Item #1:
Report Of AC Meeting - April 15, 2013
Double G's Restaurant Changes

AGENDA
ARCHITECTURAL COMMISSION
REGULAR MEETING
Monday, April 15, 2013 at 7:00 P.M.

TO: Village President and Village Board
FROM: James M. Hogue, Village Planner
DATE: April 17, 2013
RE: Board & Commissions Report for 4/23/13

ITEM #2: For the ARCHITECTURAL COMMISSION on MONDAY, April 15th @ 7:00 P.M.

PROPOSED MONUMENT SIGN

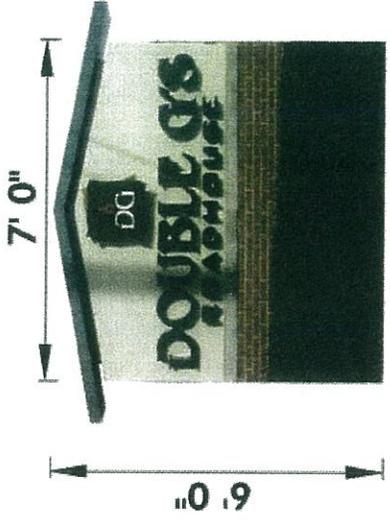
A motion was made by Commissioner Calas, seconded by Commissioner Plunkett to recommend approval of the second monument sign, which shall mirror the existing monument sign including illumination, to be located adjacent to the relocated entrance on Gilmer Road in substantial conformance with the “Proposed Building Signage” exhibit presented to the AC on 4.15.13. On a voice vote; all aye.

The proposed ground sign will mirror the existing ground sign with a total square footage of signage of approximately 45 sq. ft. per sign face. Petitioner proposes that internally illuminated LED's (light emitting diodes) be used to illuminate the "logo" (DG & Flame) and copy on the sign. The sign is proposed to be constructed of an aluminum face with black & white film applied to an acrylic surface on the "Double G's" and "Roadhouse" copy. The logo will be face lit/backlit with Red Halo-Lit illumination. Background colors include Light Tan, Dark Brown, Dark Tan & Black.

PROPOSED BUILDING SIGNAGE - NORTH ELEVATION

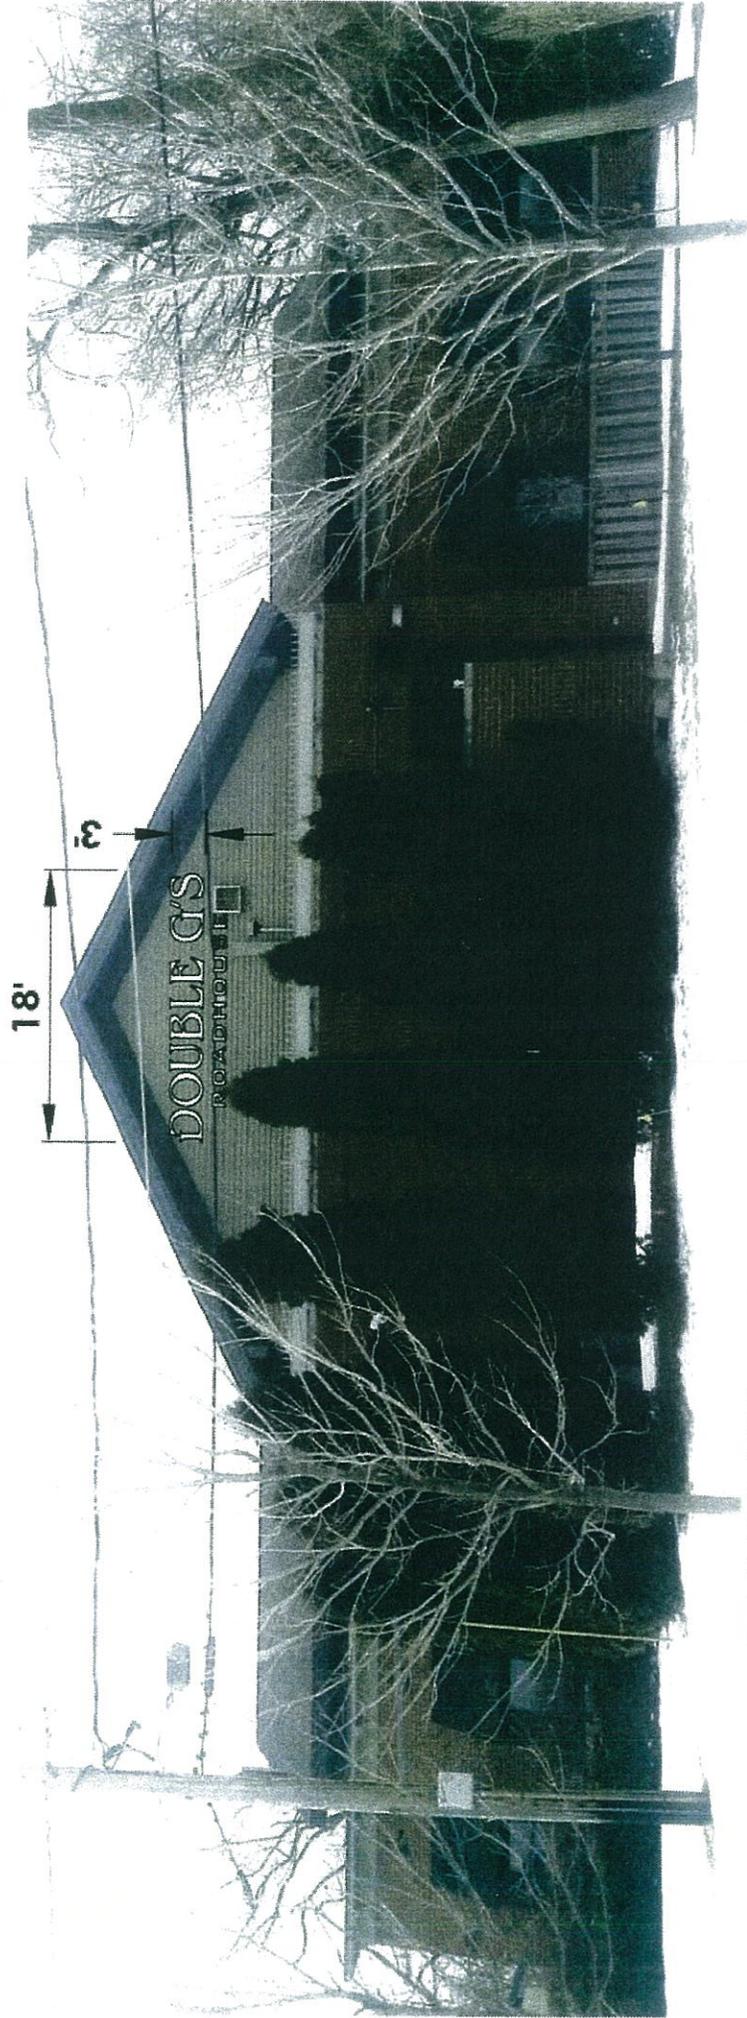
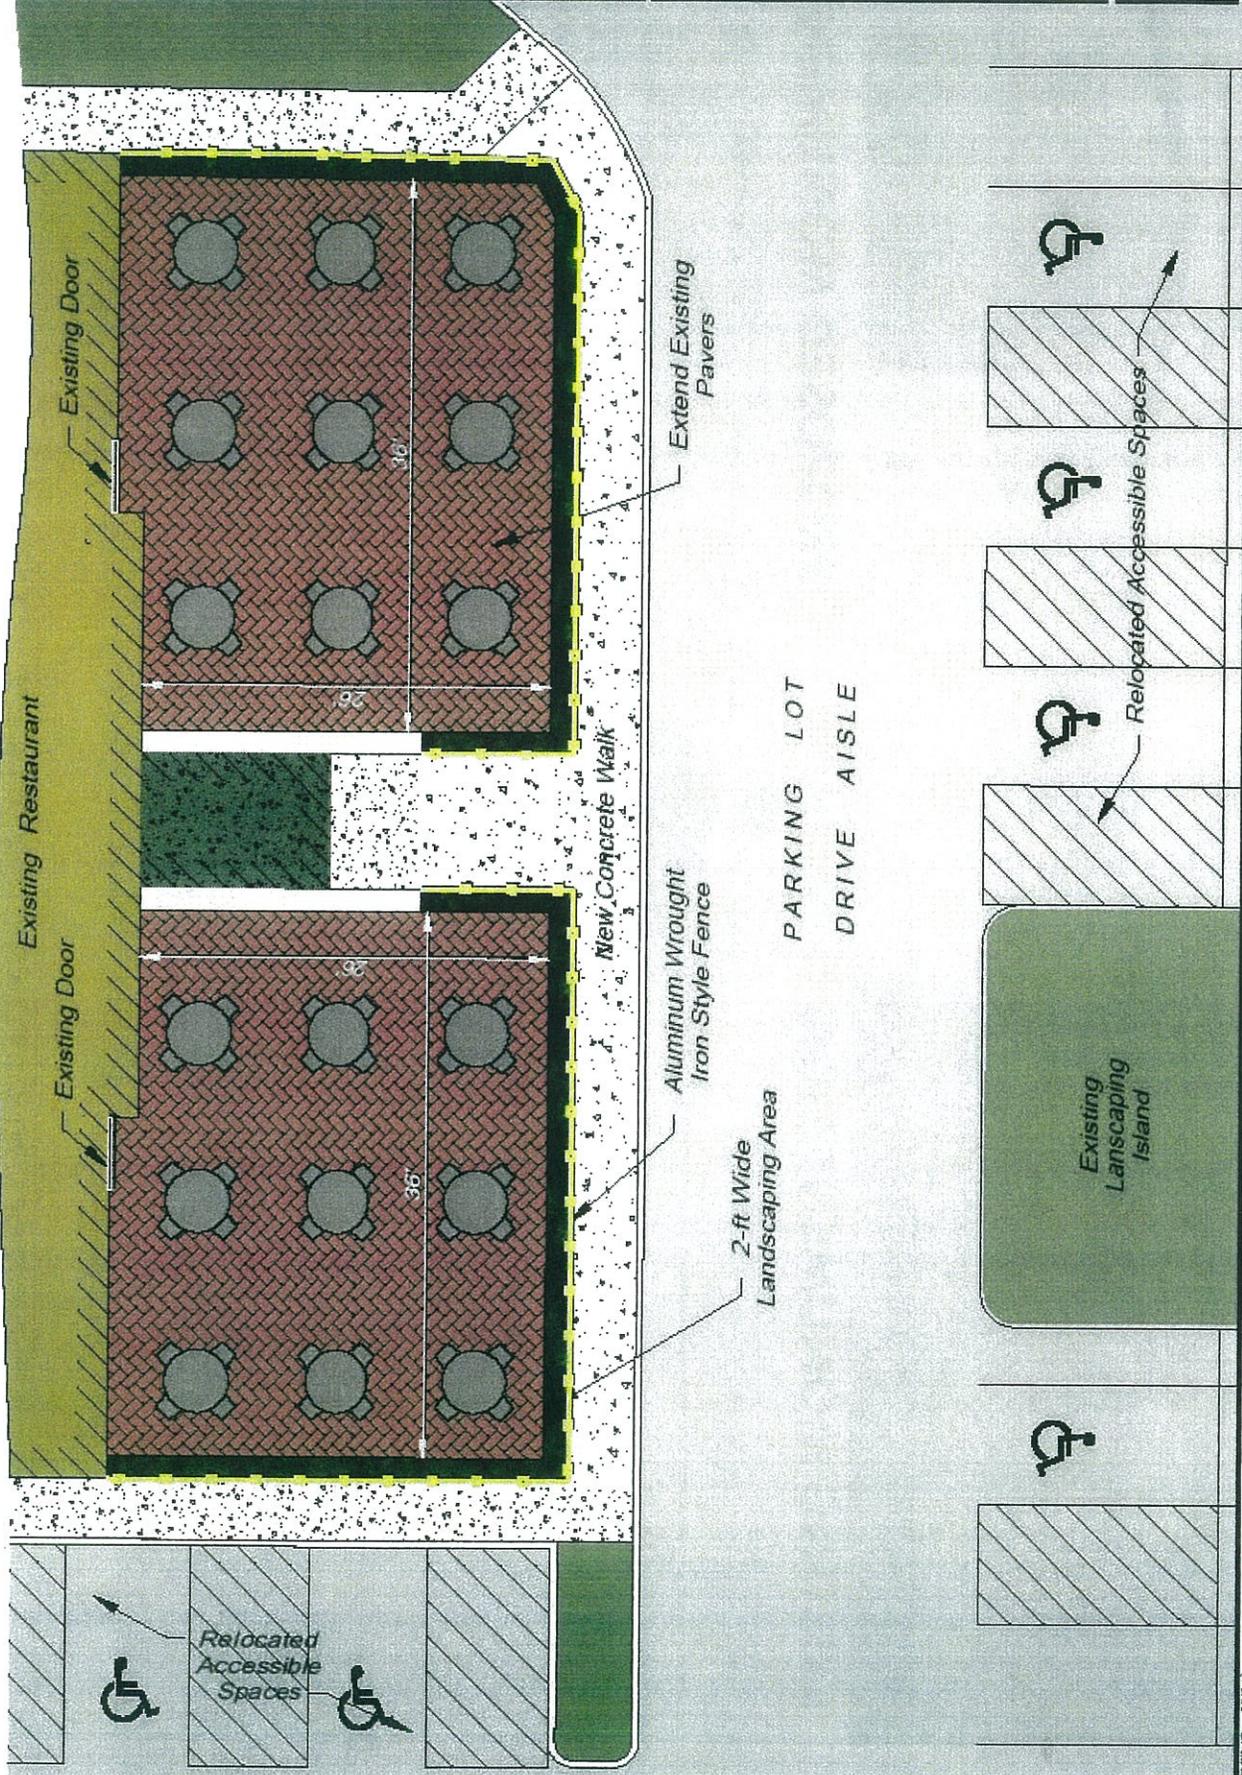
A motion was made by Commissioner Plunkett, seconded by Commissioner Calas to approve the wall sign as submitted with regard to font and general placement on the north building elevation as illustrated on the “Proposed Building Signage” exhibit presented to the AC on 4.15.13. The motion was approved subject to the following condition.

The wall sign proposed for the north façade of the building will measure 3' x 18' and contain approximately 54 square feet of signage. Petitioner is proposing aluminum channel letter signage, with transparent lettering and shine-through LED lighting. No material list or color scheme has been submitted with this signage.

- 1) The petitioner shall submit a final “proof” of the proposed signage which identifies dimensions, materials, illumination, color scheme, copy and exact placement of the sign on the north elevation of the restaurant building to the AC for further review and consideration.

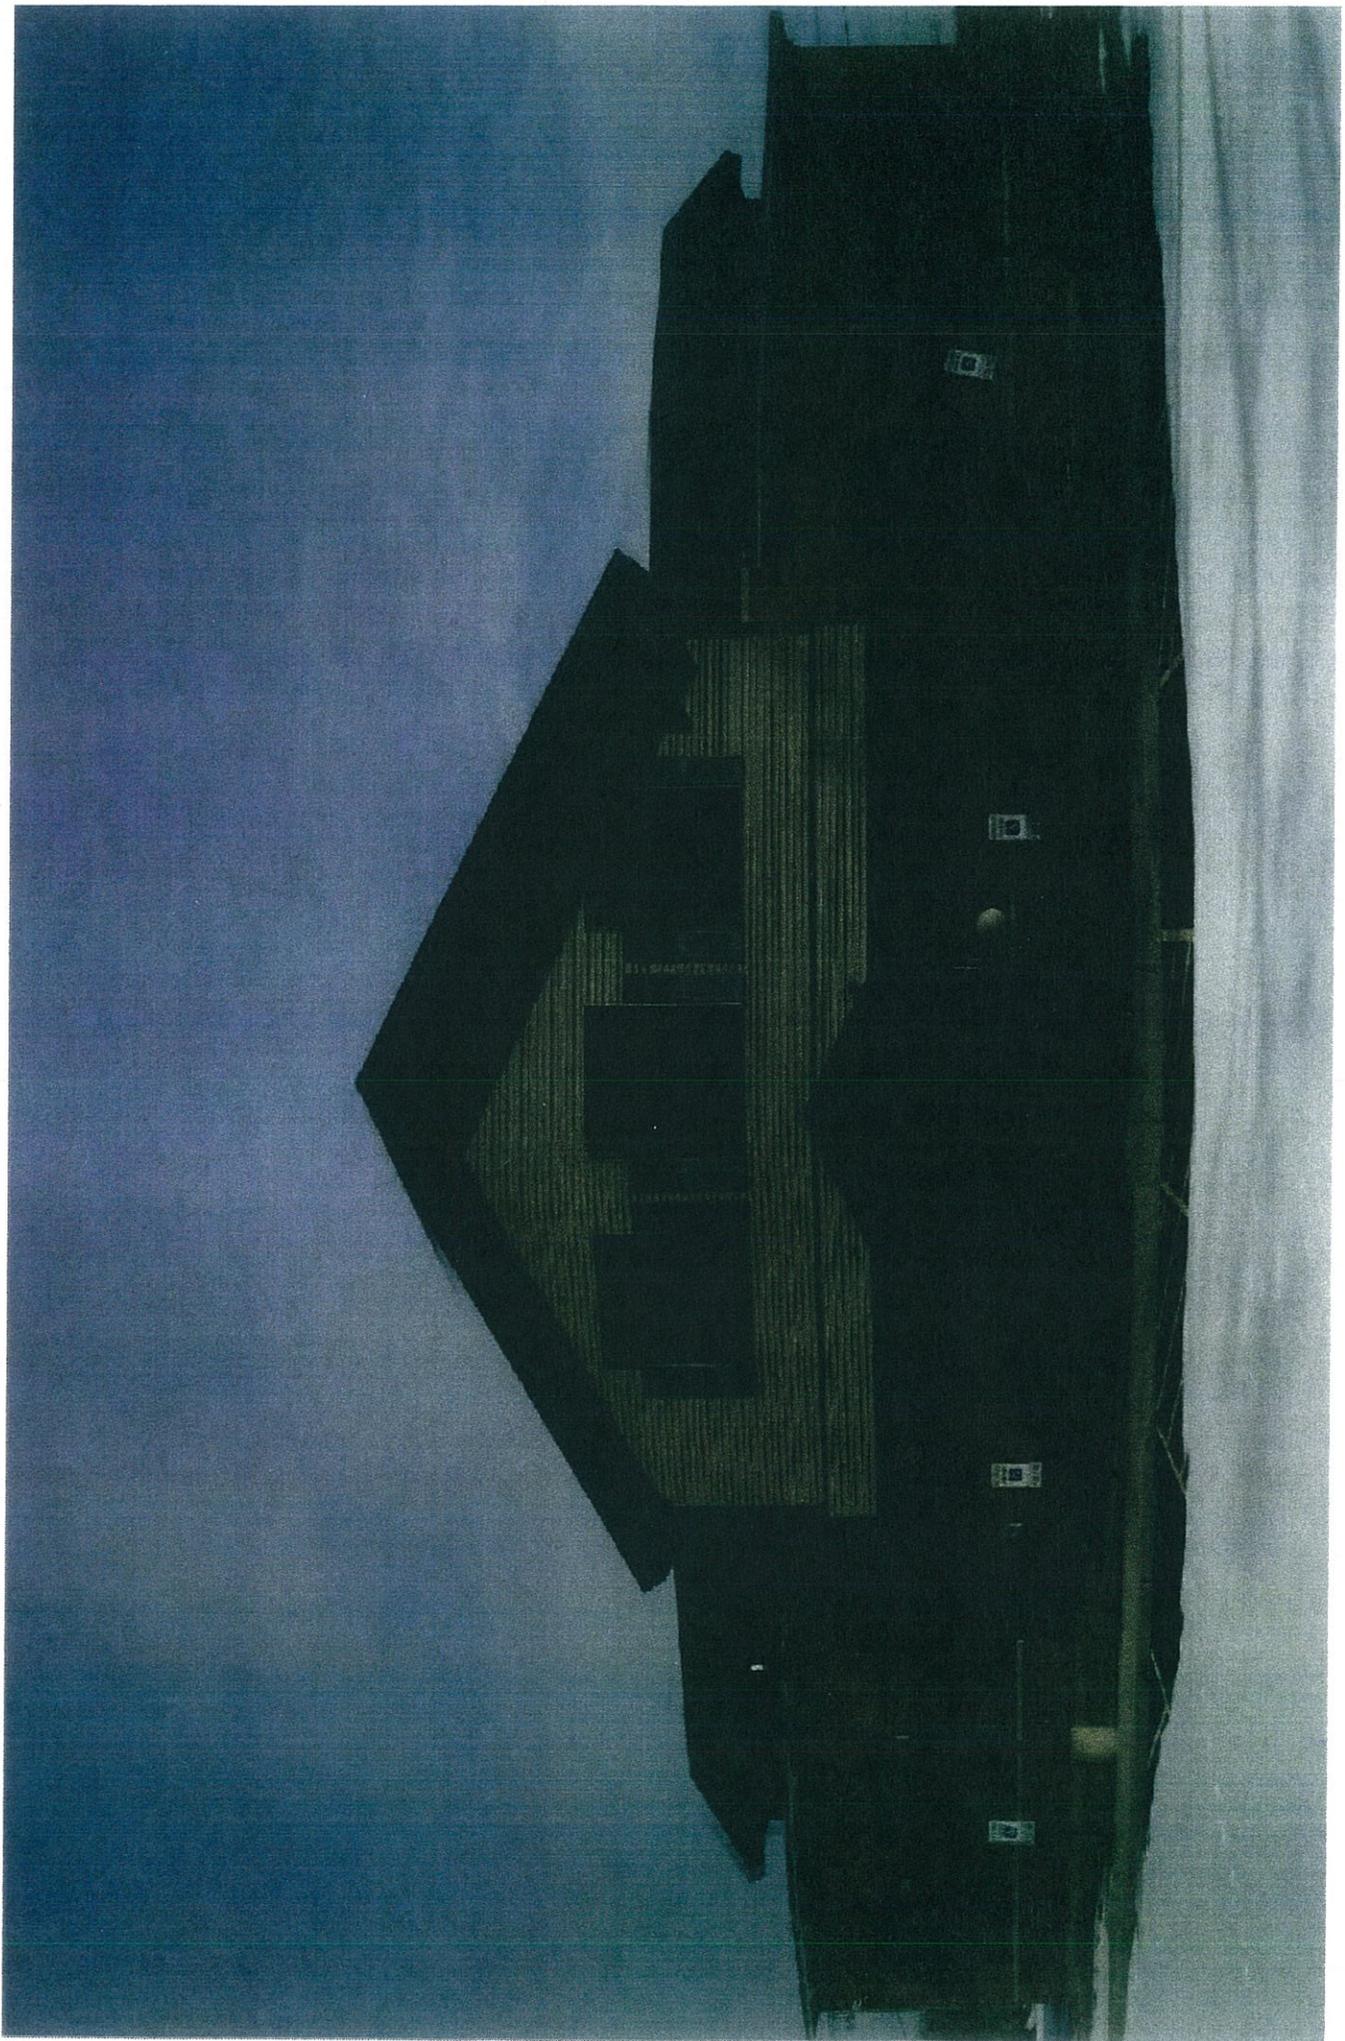
I received the updated inventory listing 3-27-13 with all the additional trees added to it. Mr. Krogstad also updated the replacement inches required. This listing shows 474" of protected trees being removed and requiring replacement. I did note that a lot of the trees requiring replacement still had conditions of 4 or 5. It had appeared to me that many of these trees with a condition rating of 4 or 5 in the inventory listing were in fair condition but may have had a lean or sweep in the trunk or some deadwood. Generally, the form of a tree is not factored into the health or condition of a tree. There are plenty of leaning trees or one-sided trees that are in fair, good or even very good condition that will still be living 40-50 years from now. Most of the trees have been growing this way their entire lives, which could have been more than 100 years for some of them. The form of a tree does not indicate that the tree is hazardous unless there is basal decay, root rot, root heave or other problems present. Deadwood in the crown of trees in a woodlot also does not automatically place a tree in poor condition. The percentage of deadwood and where it is located within the crown is more important in determining the health of the tree. Deadwood in the lower canopy of a dense woodland can be normal due to the amount of light that reaches these branches. If the deadwood is concentrated in the top center of the crown, then the tree is probably declining.

Mr. Krogstad indicated that the landscape plan dated 03/4/13 will not change as there was the maximum amount of plant material proposed as the site could handle. New plantings shouldn't be installed in areas where they will impact the existing plantings. This landscape plan shows those plants required for the buffer, yard and interior parking, with a total of 162". It also included replacement plantings for a total of 87". The difference from the 474" would have to be made up either by fee in lieu of planting and/or upgrading the sizes on the new plant material.

PROPOSED SITE PHOTOMETRIC PLAN
FOOT-CANDLE UNITS

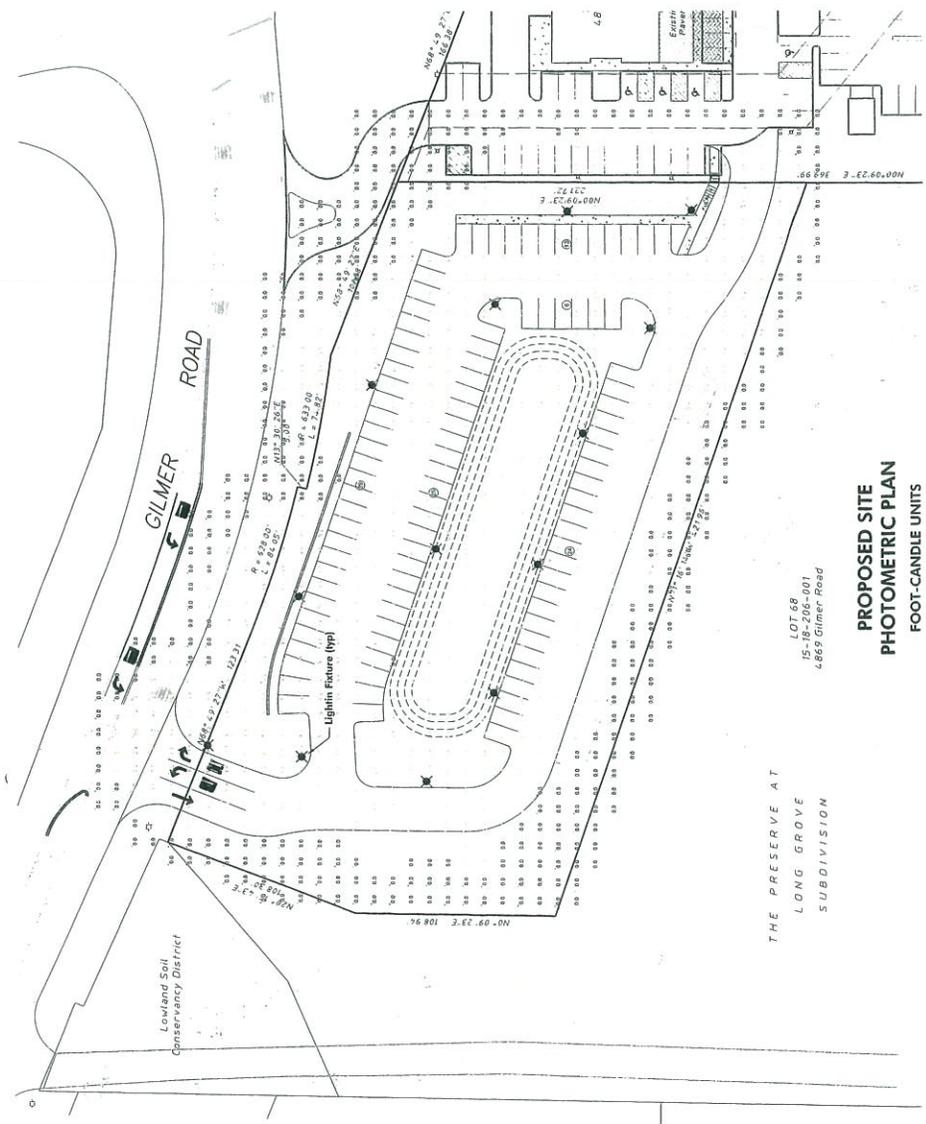
- Lighting – The AC found the photometrics as proposed acceptable. Fixtures are to match the fixtures already on-site and in the existing parking area. A motion was made by Commissioner Tapas, seconded by Commissioner Calas to recommend approval of the site lighting\ photometric plan prepared by Haegar Engineering as revised 4-10-13 and presented to the AC on 4.15.13. The motion was approved as follows;

Twelve (12) 250 watt fixtures with a metal halide light source are proposed for parking lot lighting on Lot 68. Fixtures have been located more or less toward the inside perimeter of the proposed parking area thereby minimizing the possibility of glare to adjacent residences particularly to the west of Lot 68. Metal halide light sources are permitted with AC approval; however, light sources over 200 watts are not permitted.

- 1) Twelve (12) fixtures matching the existing on-site fixtures shall be permitted as depicted on the site lighting\ photometric plan prepared by Haegar Engineering.

- 2) Fixtures shall be less than fifteen (15) feet in height with a 250 watt light metal halide light source.
 - 3) Petitioner shall submit specifications for any additional exterior lighting proposed for the outdoor dining area including types of fixtures, illumination source, wattage and fixture placement to the AC for further review and approval.
